HILLIARD PLANNING AND ZONING BOARD MEETING

TUESDAY, FEBRUARY 13, 2024, 7:00 PM

SUBJECT: Planning and Zoning Board approval of the Site Plan Application No. 20221025.
Parcel ID No. 17-3N-24-2020-0057-0000. Address 3714 Raven Drive.
Property Owner- Gregg Simmons

HILLIARD RV	
EXISTING CONDITIONS	
Date:	06/2022
Designer:	HAV
Job #:	21-071
Drawn:	MRP
Scale:	1:60
Sheet:	3

10.01

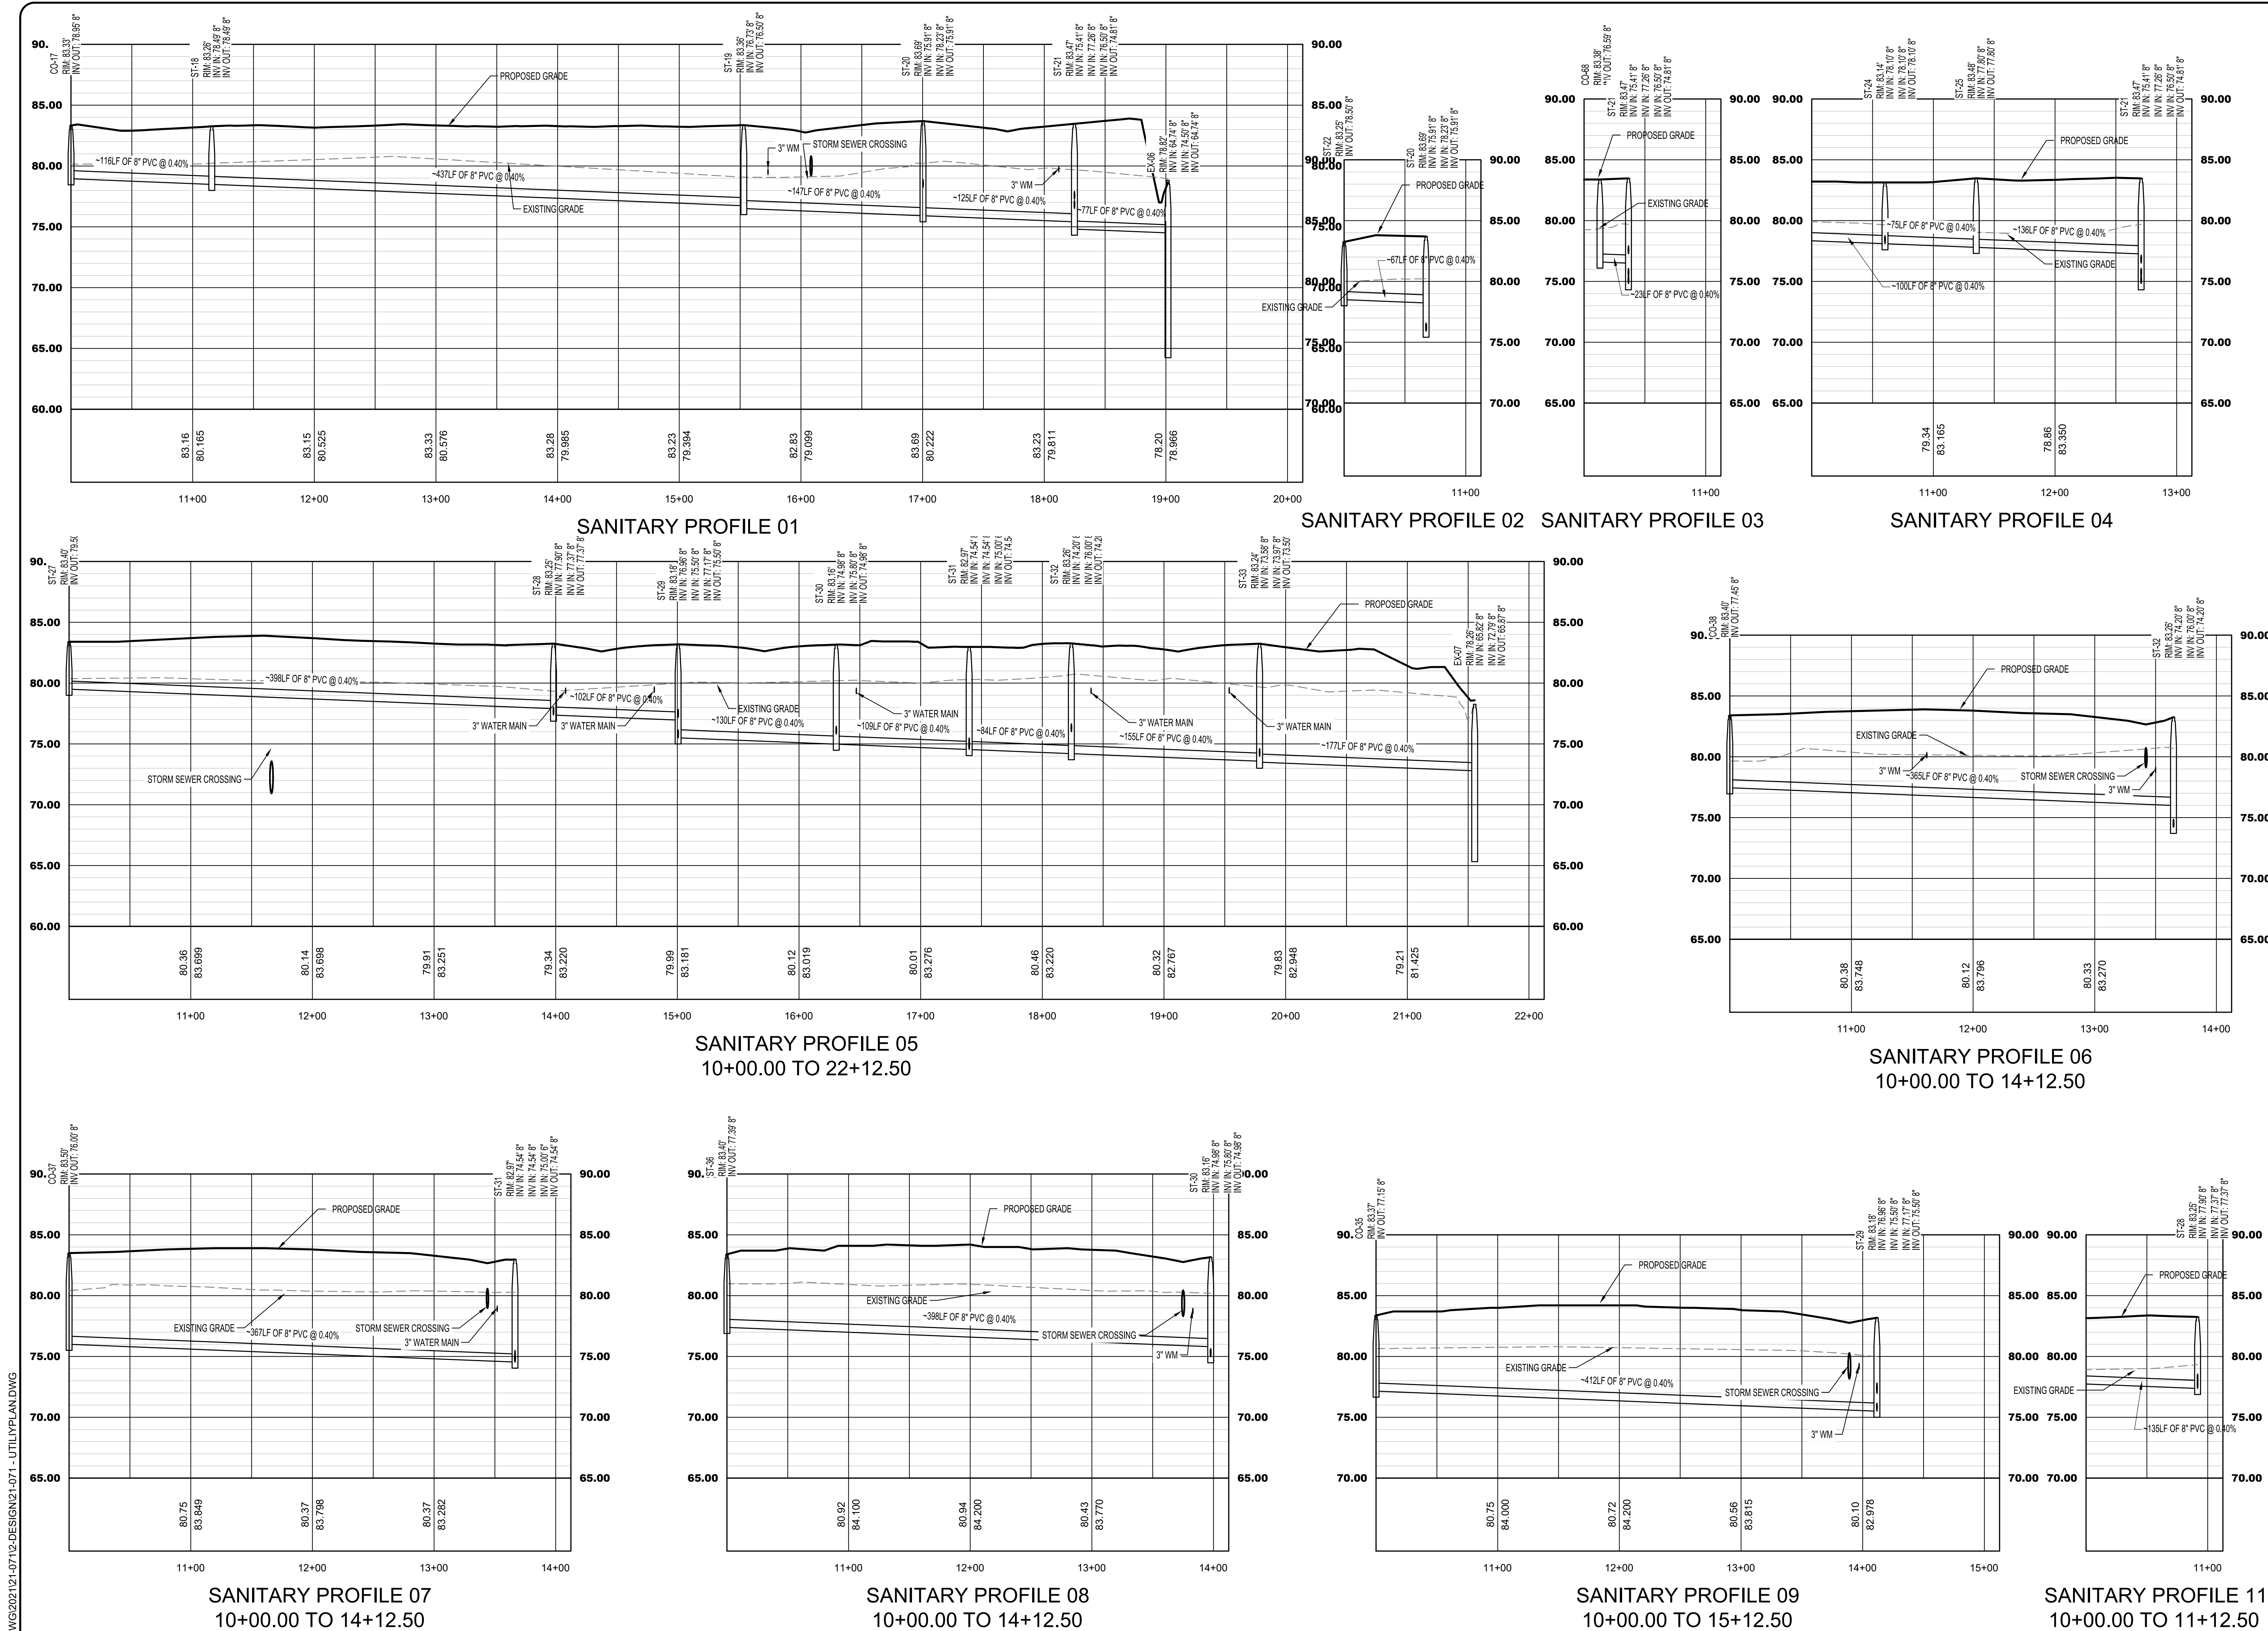
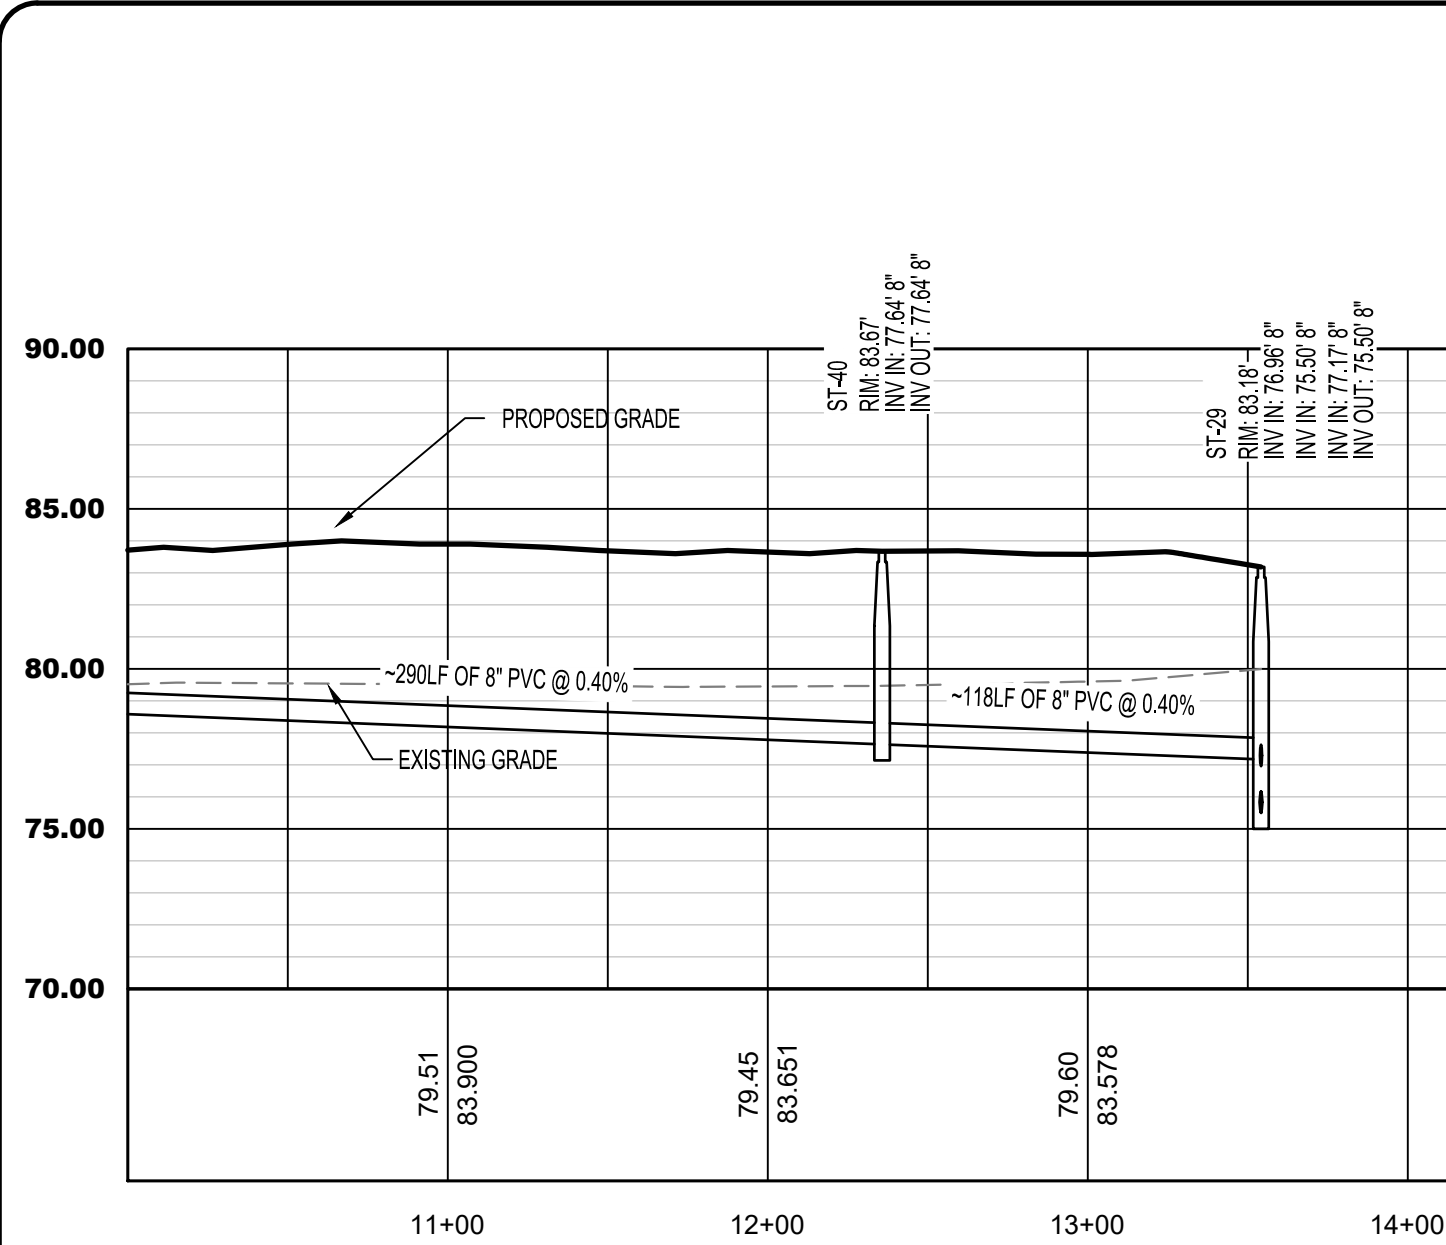
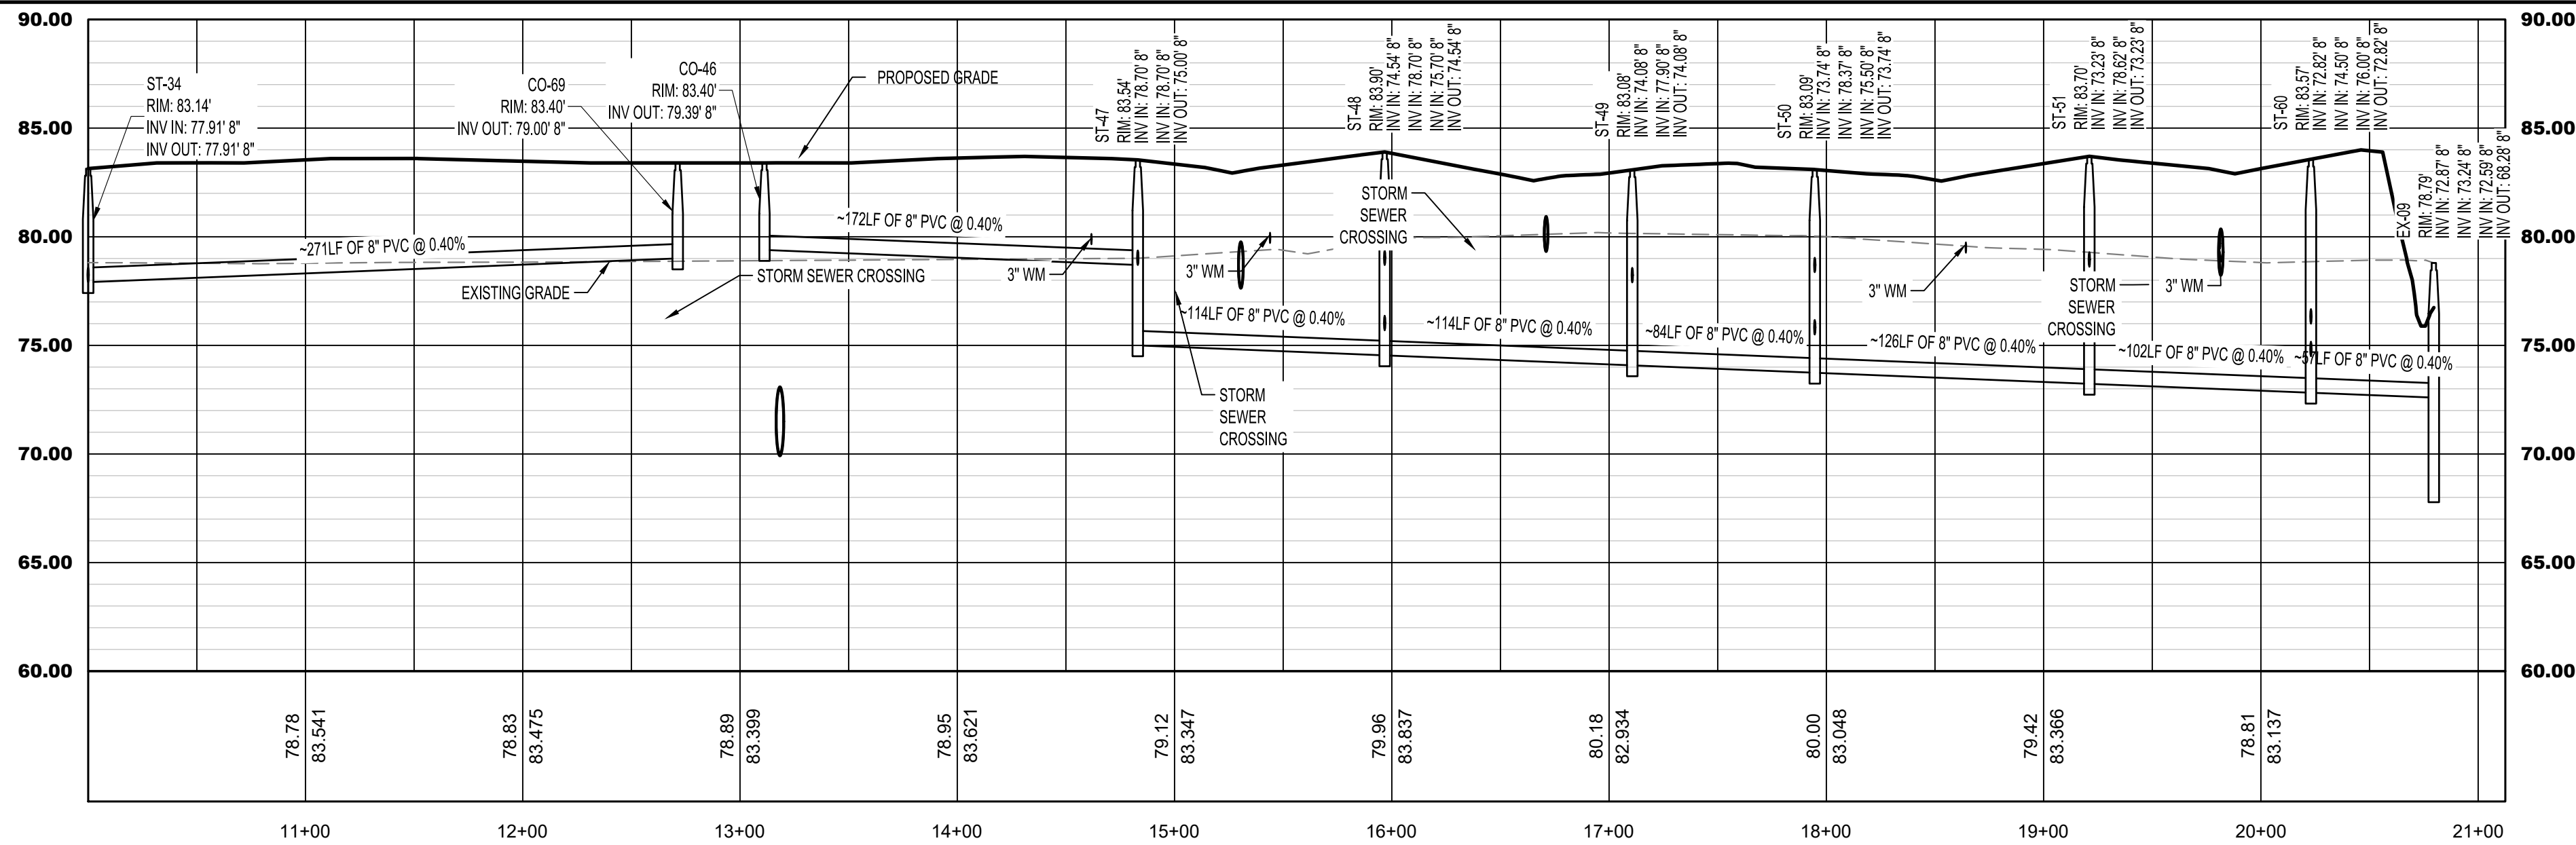
12. ST-37 to ST-31 (Sanitary Profile 07 on Sheet 10.01) is sloped incorrectly and will flow in the wrong direction. Correct inverts and slopes, as required.

1. Revise the profiles to reflect and be consistent with the design presented on the Sheets 9.01-9.05. This includes, but is not limited to, the following:
 - a. Profile 1 - ST-17 not shown
ST-17 was added to the profile.
 - b. Profile 7 - Sloped in opposite direction
The slope direction was corrected.
 - c. Profile 10 - ST-39 not shown
ST-39 was added to profile 14.
 - d. Profile 11 - ST-34 and unlabeled manhole to south not shown
Profile 11 has been revised to show all appropriate manholes.
 - e. Profile 17 - ST-62 not labeled, ST-61 not shown
ST-61 was added to profile 61
2. Update the profiles to reflect any revisions made on Sheets 9.01-9.05.

PLATE W-42

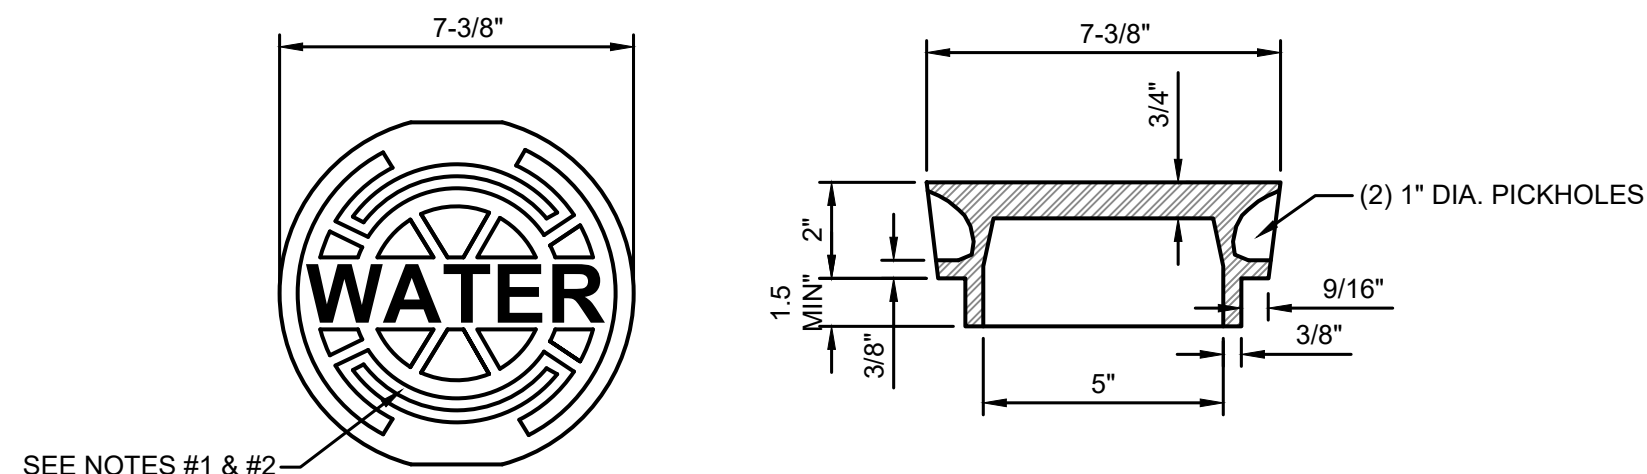
4. Open Cut Trench Plate W-42: Change, "In City Right of Way" to "In County Right of Way"

PLATE S-19

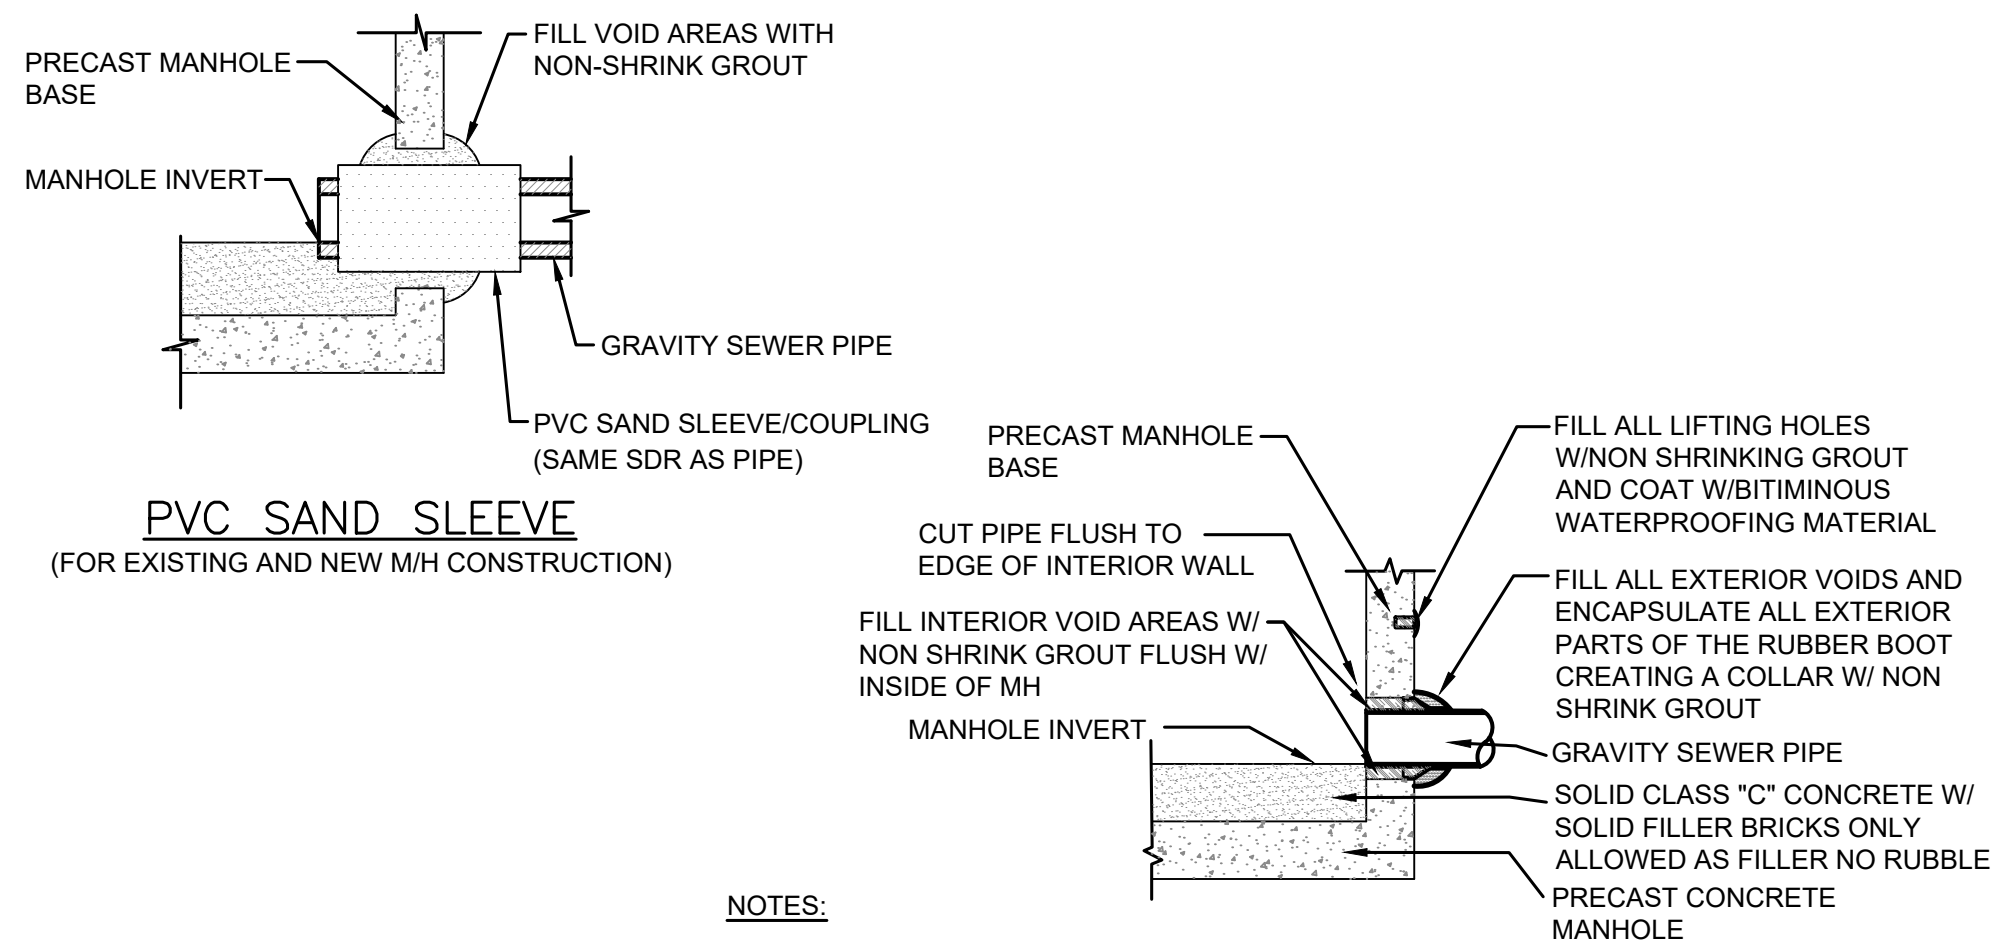
2. Sewer Lateral Plate S-19: Remove reference to JEA.

7. Plate S-19: 1. Change JEA to Town of Hilliard.
